CERTIFICATE OF APPROPRIATENESS

Applicant: Gary Trentham, Trentham Contractors Corp., for 1515 Oxford LLC, owner

Property: 1515 Oxford St, Tracts 8 and 9A, Block 136, Houston Heights Subdivision. The property is on an 8,250 square foot (62.5' x 132') vacant interior lot. Interior lots in Houston Heights were platted as 50' wide lots, although parcel lines have moved over the years so that many properties, including 1515 Oxford contain portions of multiple platted lots.

Proposal: New Construction – Construct a 4,264 square foot two-story residence and rear attached garage. The project was denied at the January 2016 HAHC meeting.

SOUTH SIDE ELEVATION

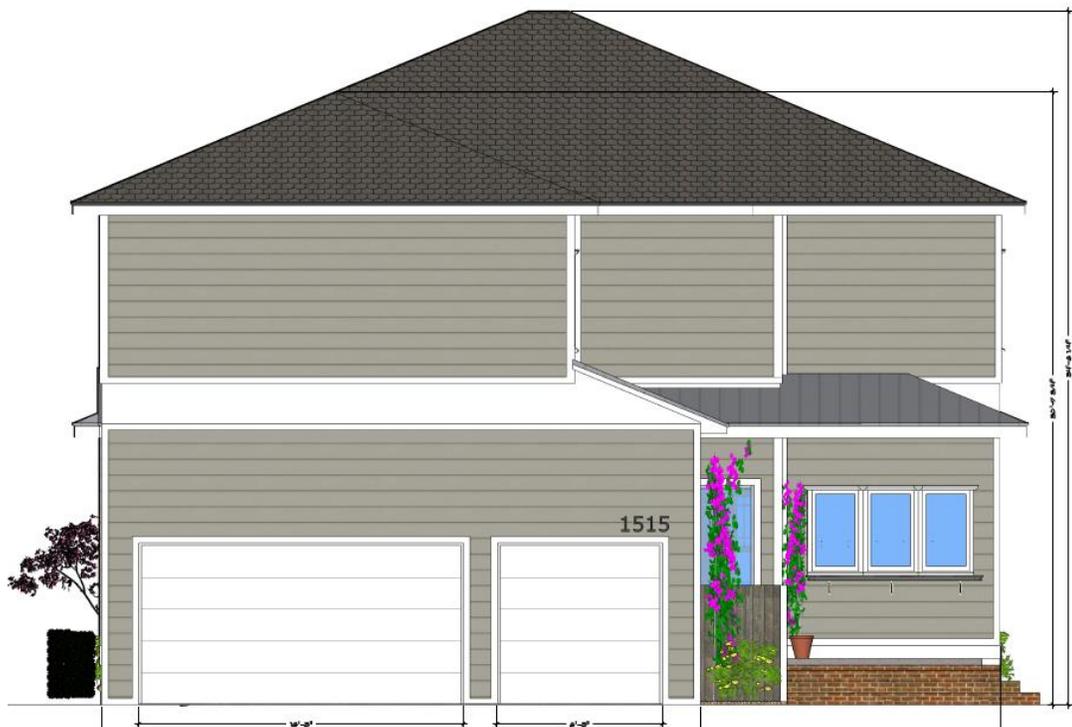
- (2) The exterior features of the new construction must be compatible with the exterior features of existing contributing structures in the context area;
Brick skirting around the foundation, fixed and 9-lite windows are not compatible features found on contributing houses within the area. The side elevations are almost entirely lacking in window openings. The lack of fenestration, uneven porch column spacing coupled with the craftsman-style windows and the Victorian-style shingles in the gable also result in incompatible features. If the elements were removed or simplified, and appropriate window openings added to the side elevations, the new construction would meet this criterion.

Side Elevation: The residence contains no windows on the first floor and six fixed 1-over-1 windows on the second floor. The first floor of the garage also features two pairs of closed shutters and the first floor of the residence contains one glass door. See elevation drawings for details.
